# Office Action Summary

Application No.  
09/126,826

Applicant(s)  
Yamazaki et al.

## **DETAILED ACTION**

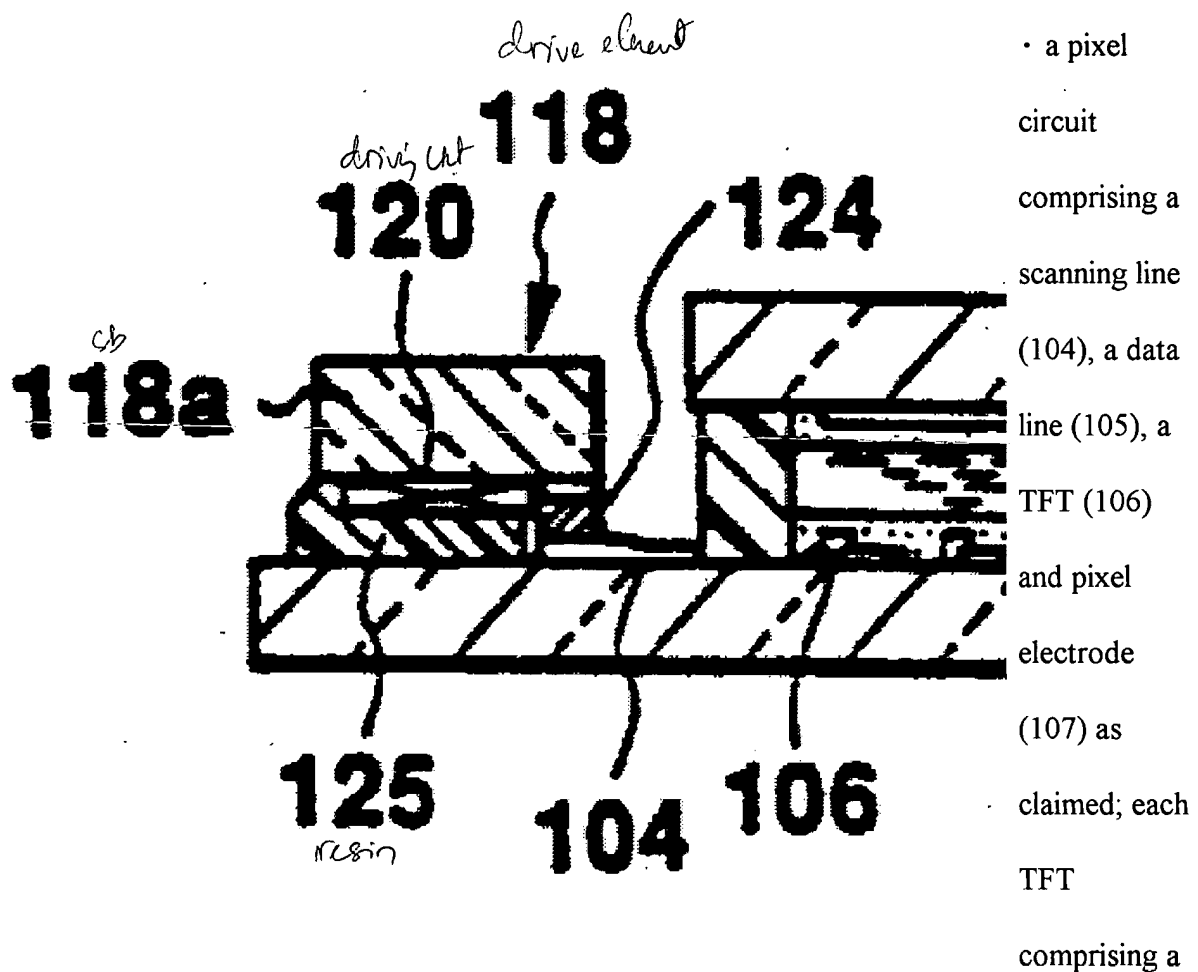
Regarding claims 72-73, 75-79, 81-83, 90-91, 93-96, 93-96 and 98-99, Mawatari et al. disclose an active matrix LCD device (figures 3-4) having:

- a pair of opposed substrate (101, 102);

channel region crystal silicon (semiconductor 110), a silicon oxide/polyimide passivation (gate insulating 109) (figure 6);

- a liquid crystal material (LC) disposed between the pair of opposed substrate;
- a resin (125) forming on the substrate (101);
- a base film (substrate 118a) in contact with the resin (see enlarged figure 4 reproduced above);

- a driver circuit (120) comprising thin film transistors (TFTs) formed on base film (118a);
- a passivation film inherently covered TFT having a contact hole for electrical connection through a tapered configuration (according to matrix LCD);

Although Mawatari et al. do not explicitly disclose that the driver TFT including a passivation film having a contact hole connected to the pixel TFT by a wiring, it would have been obvious to one skilled in the art to form a driver TFT having a passivation layer and a wiring to connect the pixel TFT from the driver TFT as shown by Yamazaki et al figure 4C in order to drive the pixel TFT in an LCD device.
